| <u>Technical Specification Page No.</u> | <u>Technical Specification Section</u> | <u>Description of Change</u> | <u>Reason for Change</u> |
| B3/4 2-7 | Fig. B3/4.2.3-1 | Replace the current operating map with a new operating map. | MEOD |
| B3/4 2-8 | Fig. B3/4.2.3-2 (new) | Add an operating map for single recirculation loop operation. | Clarification |
| B3/4 6-5 | B3/4.6.2.5 | Revise the value for drywell peak calculated pressure from 18.9 psig to 19.7 psig. | MEOD |

Figure 3.2.1-1 Flow-Dependent MAPLHGR Factors (MAPFAC_f)

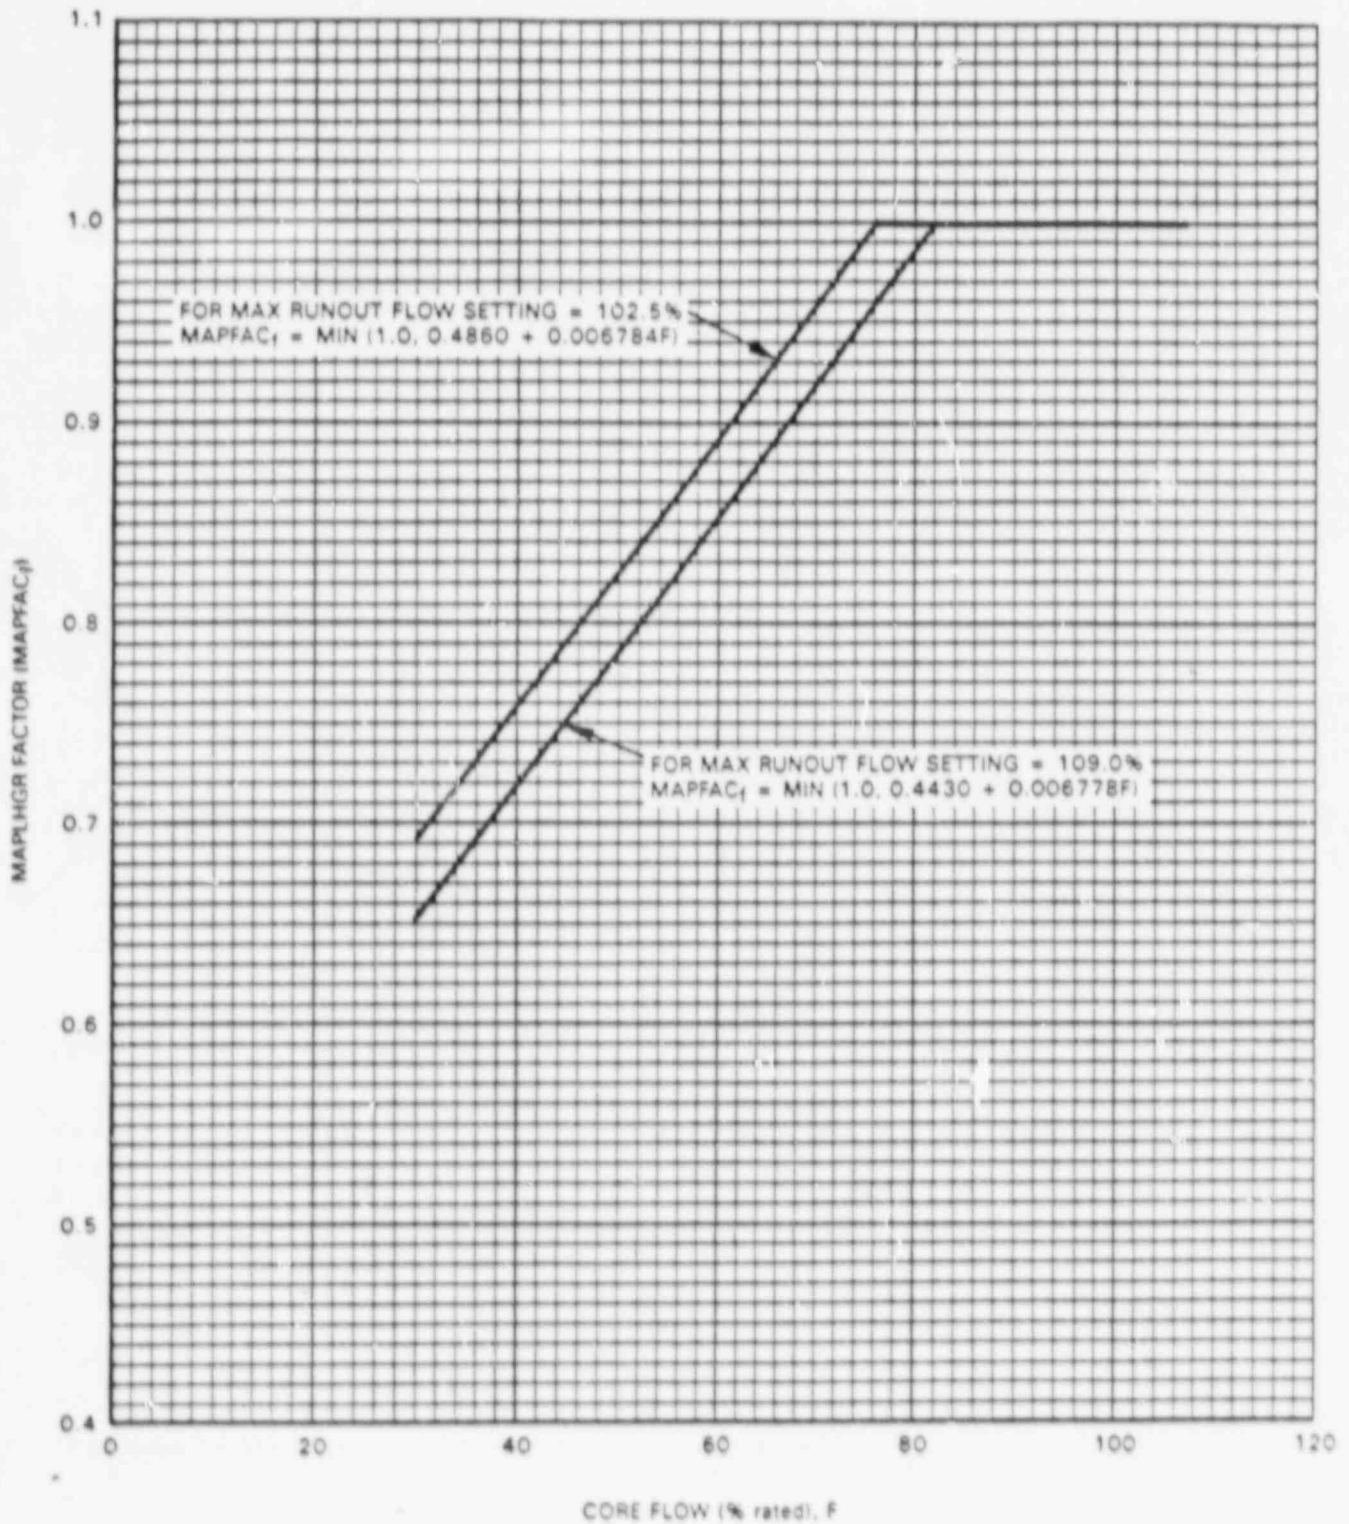
New Figure

Technical Specification Bases 3/4.2.1: A paragraph is being added to this section to discuss how $MAPFAC_f$ and $MAPFAC$ are to be used, and how $MAPFAC_f$ and $MAPFAC$ are determined. The source of this information is section 2.6.3 of the MEOD analysis.

Figure 3.2.1-6 Maximum Average Planar Linear Heat Generation Rate (MAPLHGR) Versus Average Planar Exposure - Reload 1 Fuel Type BP8SRB284L

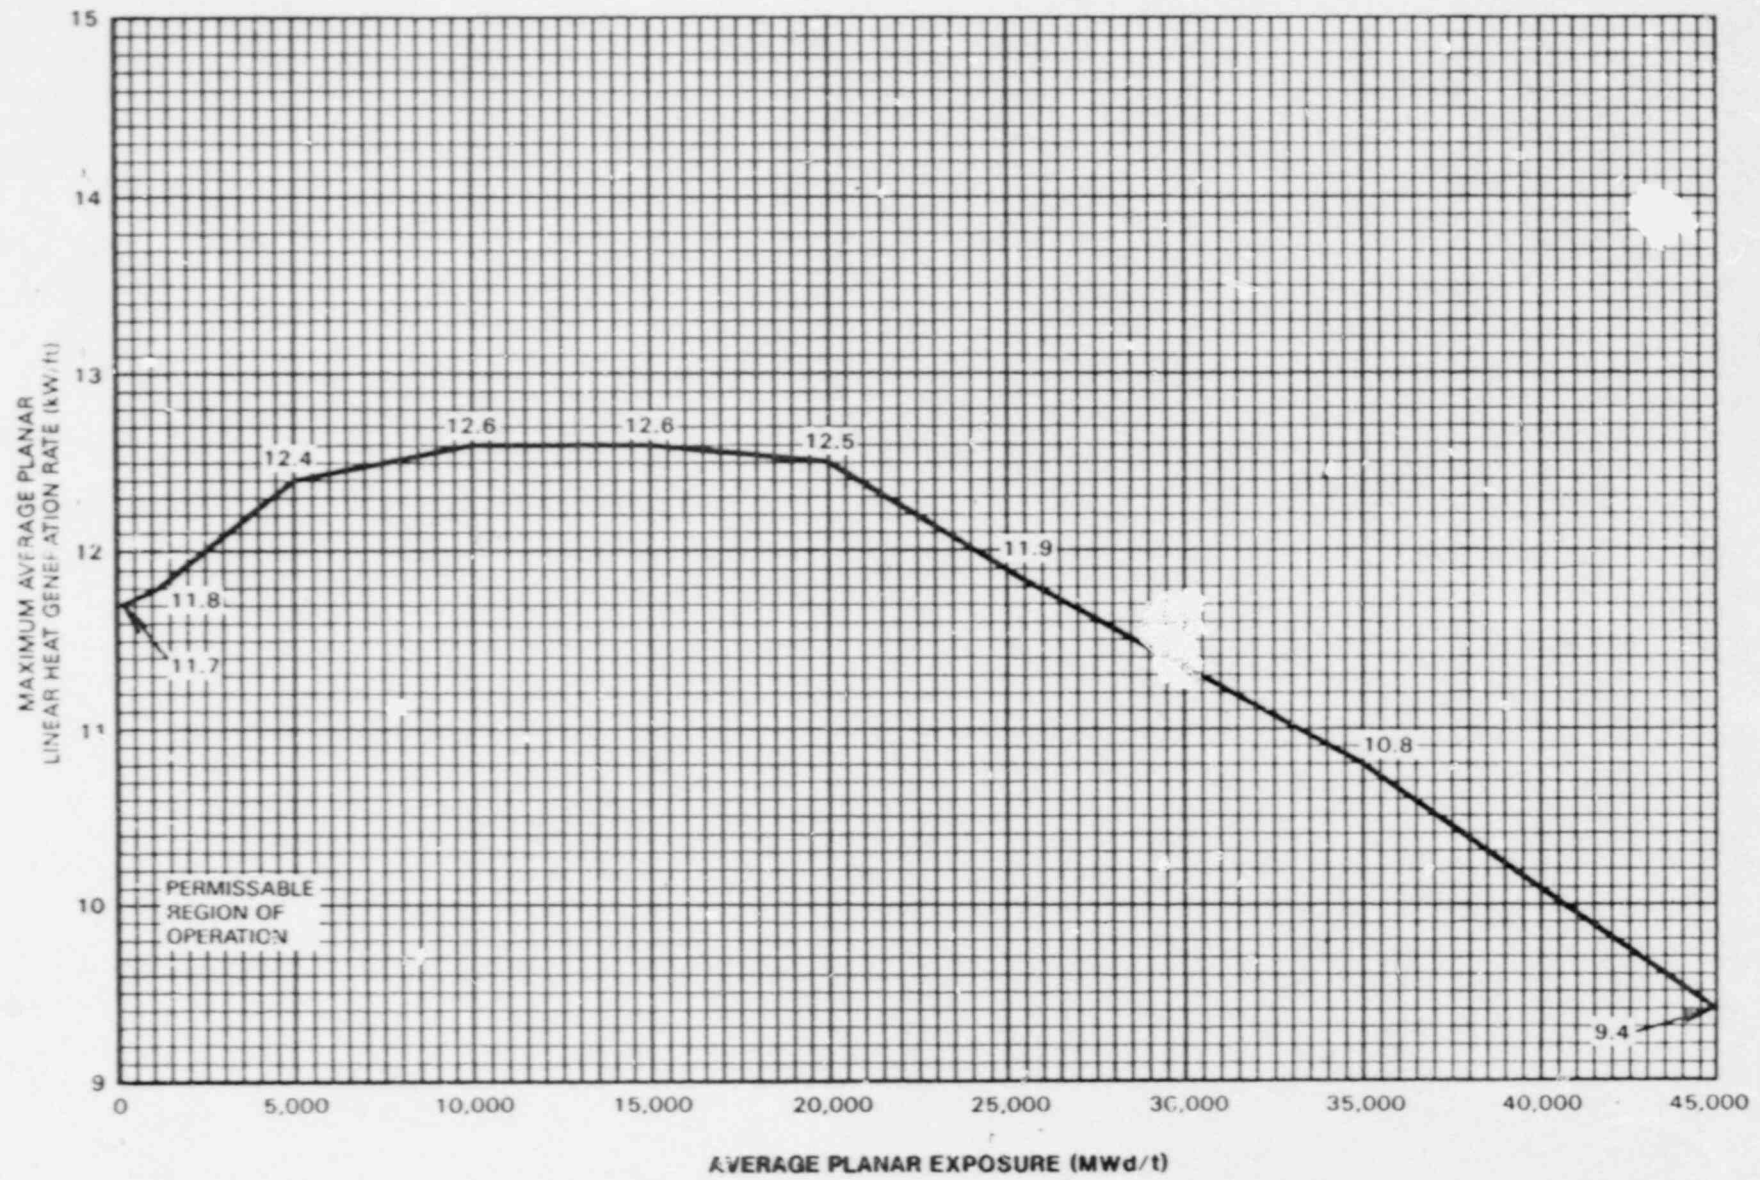
New Figure

The reload analysis allows operation with two new fuel types. MAPLHGR curves for these new fuels are being added to the Technical Specifications to ensure that ECCS peak clad temperature (PCT) and LHGR limits are not exceeded as established by applicable analyses. Analysis shows that the PCT for the two new fuel types (for the postulated DBA LOCA) is 2078°F which is well below the 10CFR50.46 limit of 2200°F. Therefore, this change does not increase the probability or consequences of any accident previously analyzed.

Figure 3.2.3-1 Clinton $MCPR_f$ Versus Core Flow

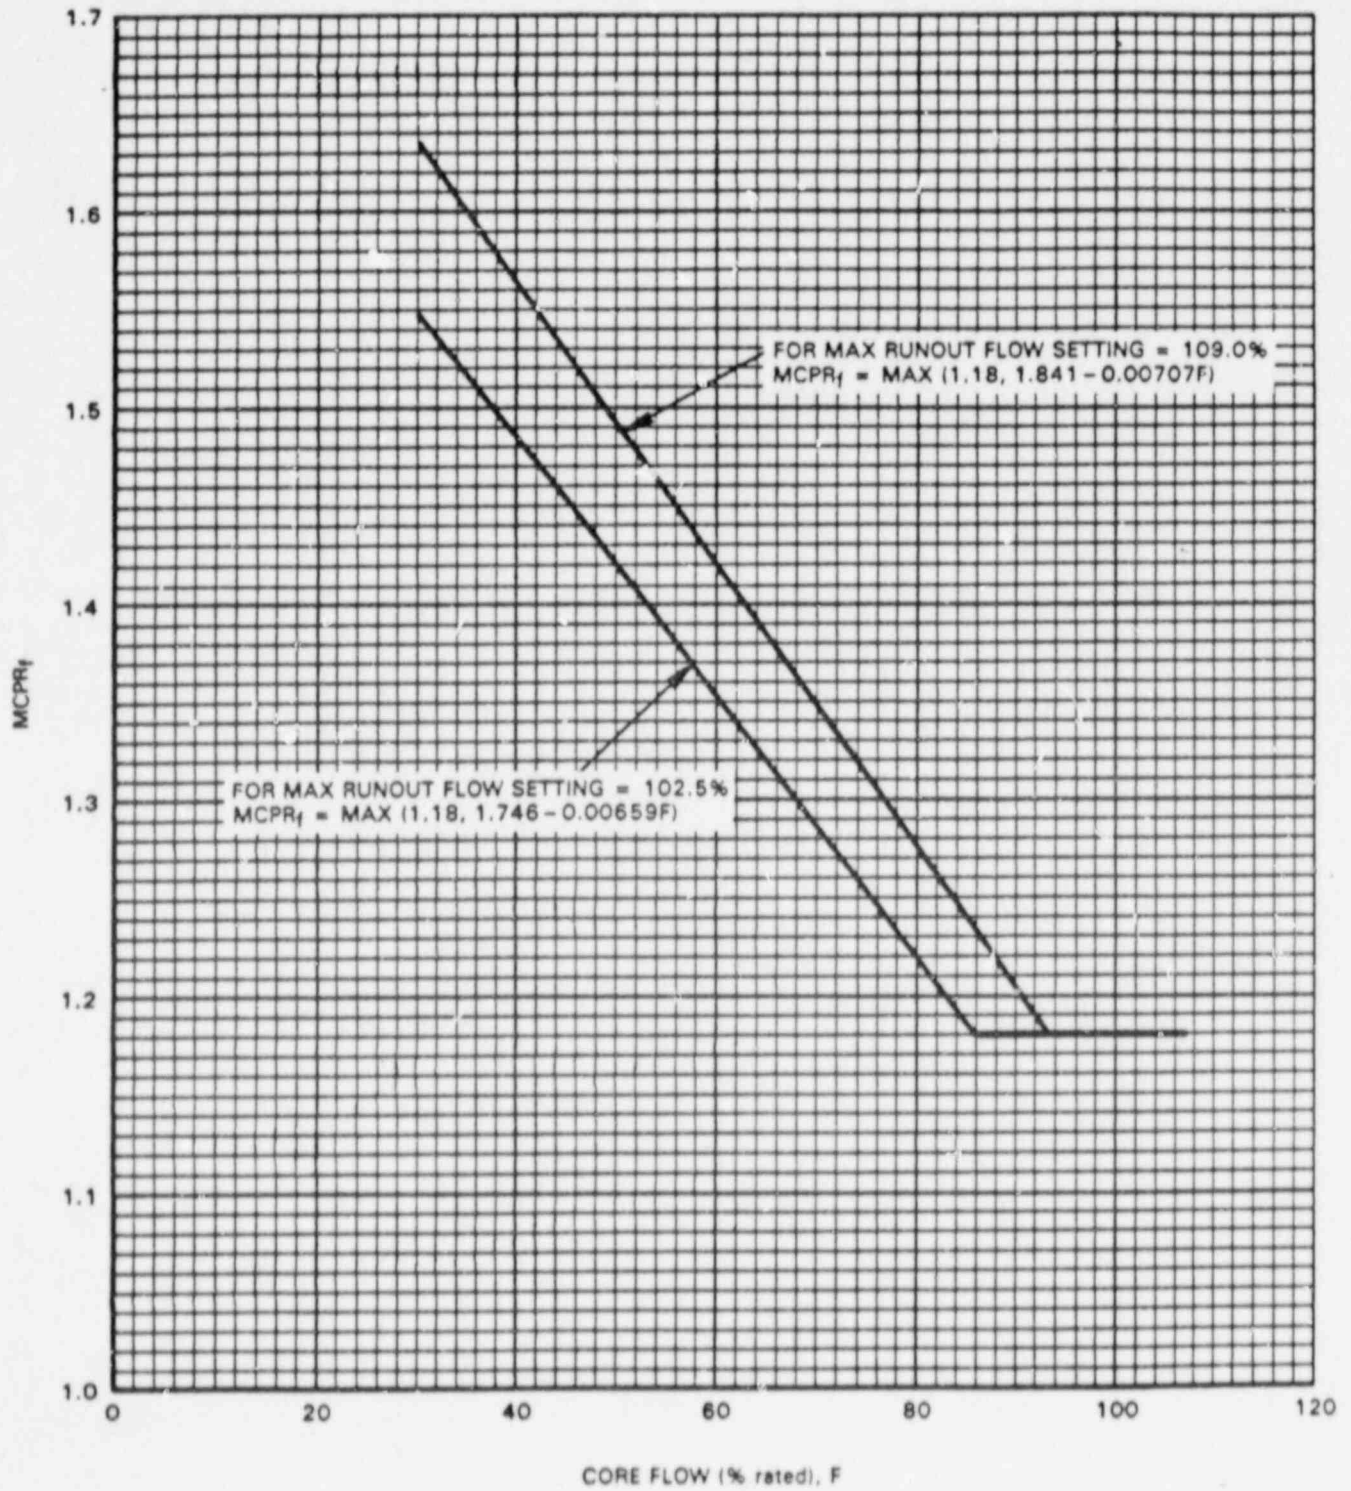
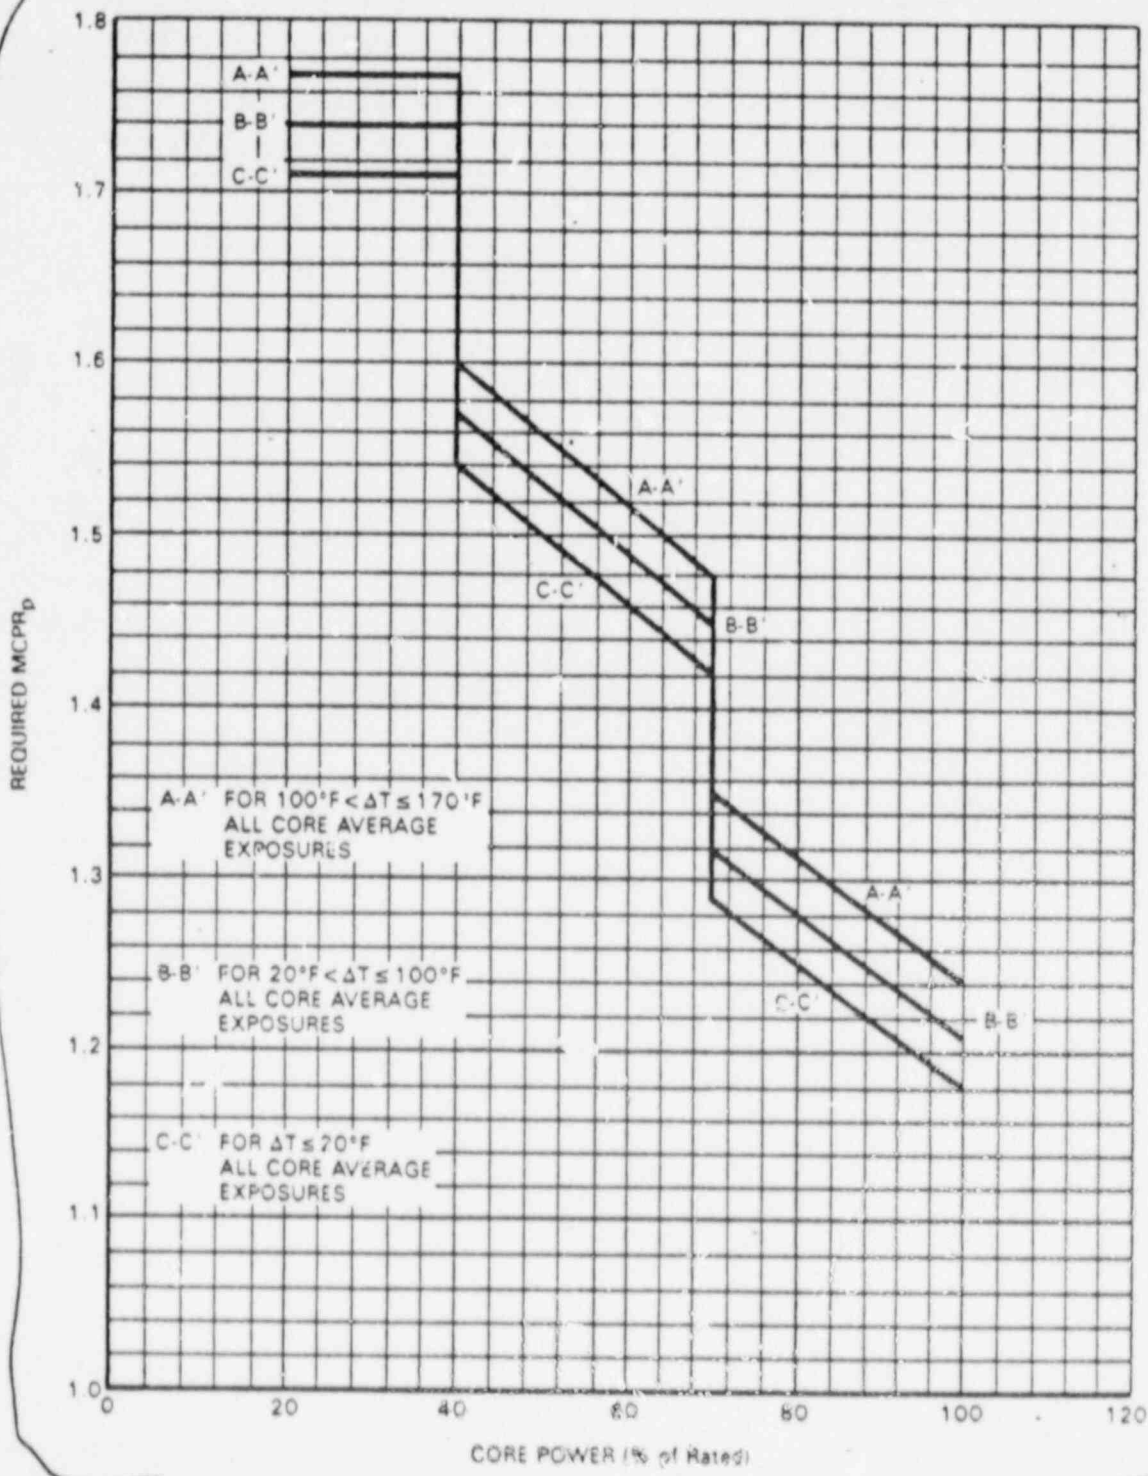
Replace with revised
Figure 3.2.3-1 attached

The operating limit MCPR at any power/flow condition is the larger of the new $MCPR_f$ and the $MCPR$. The new values are presented in the revised Figures 3.2.3-1 and 3.2.3-2.

Figure 3.2.3-2 Clinton MCPR_p Versus Power for $\Delta T \leq 50^\circ F$ and Core Flow $\leq 107\%$

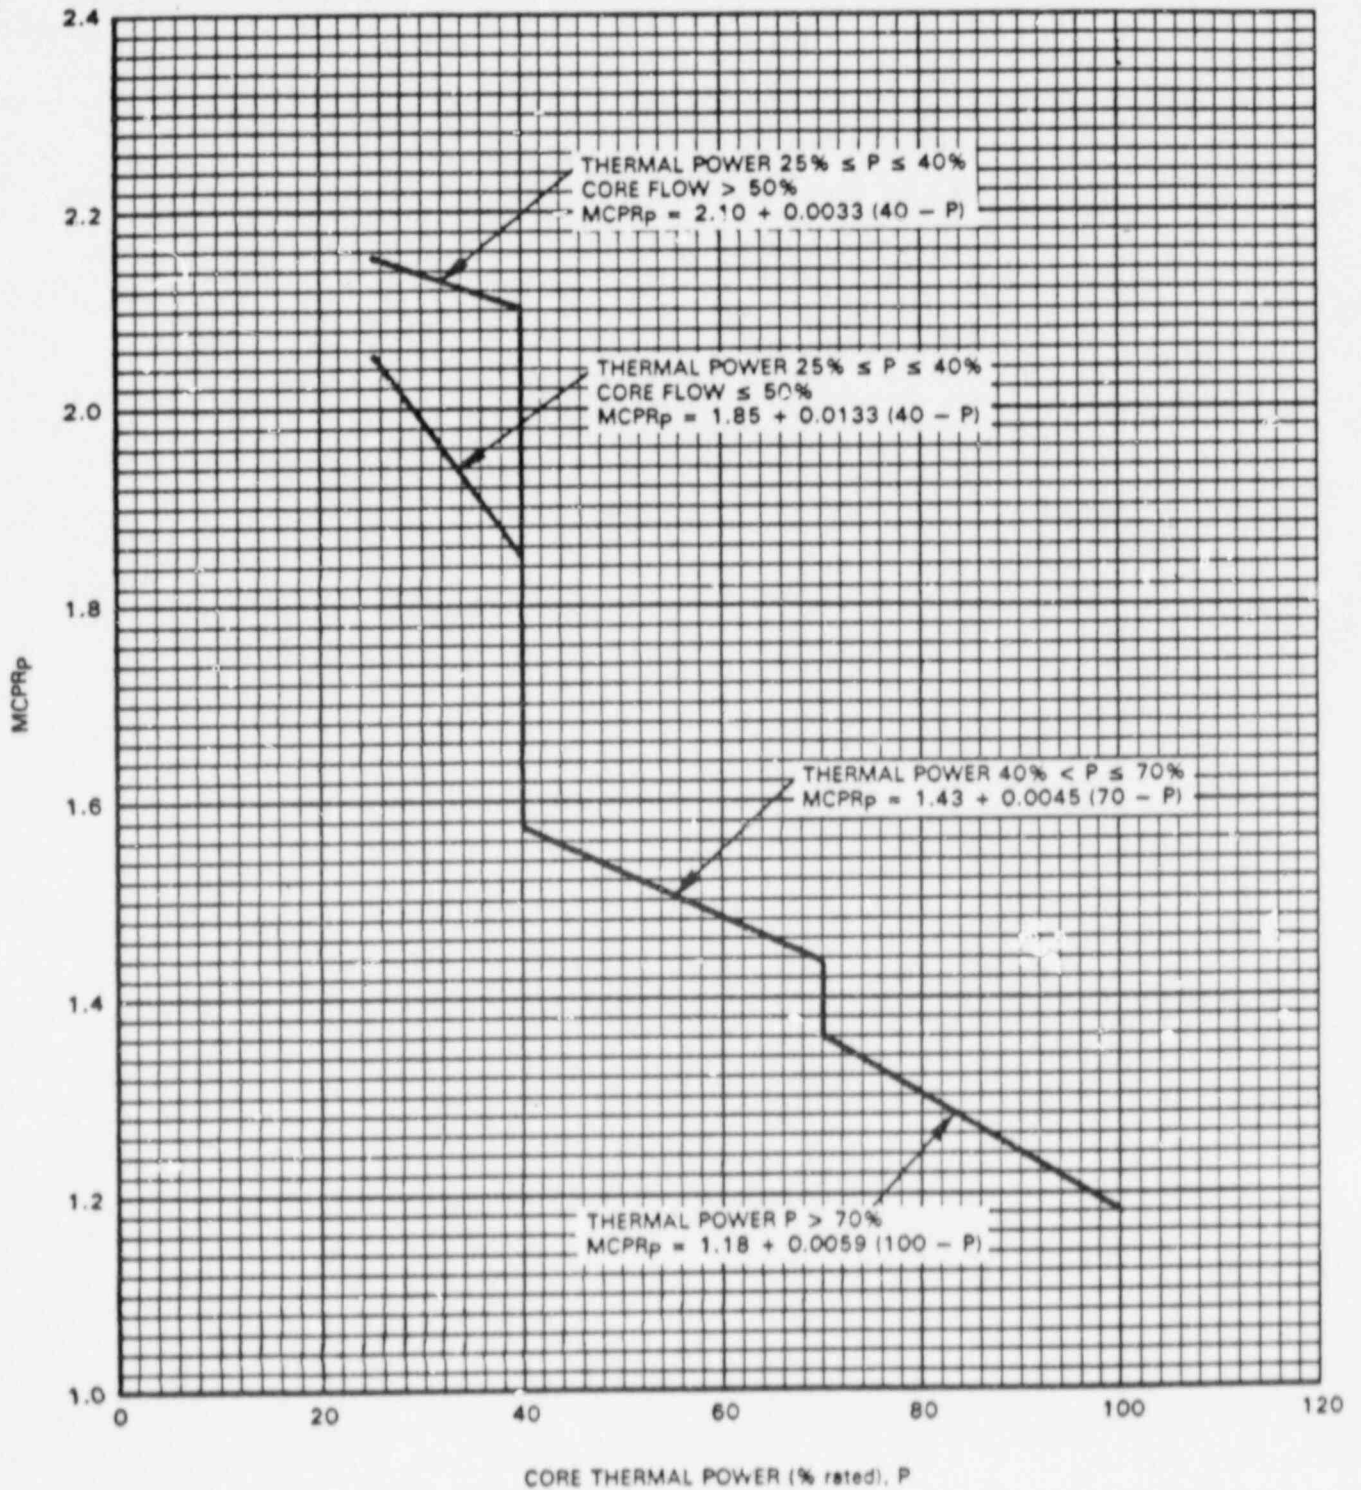
Replace with revised
 Figure 3.2.3-2
 attached.
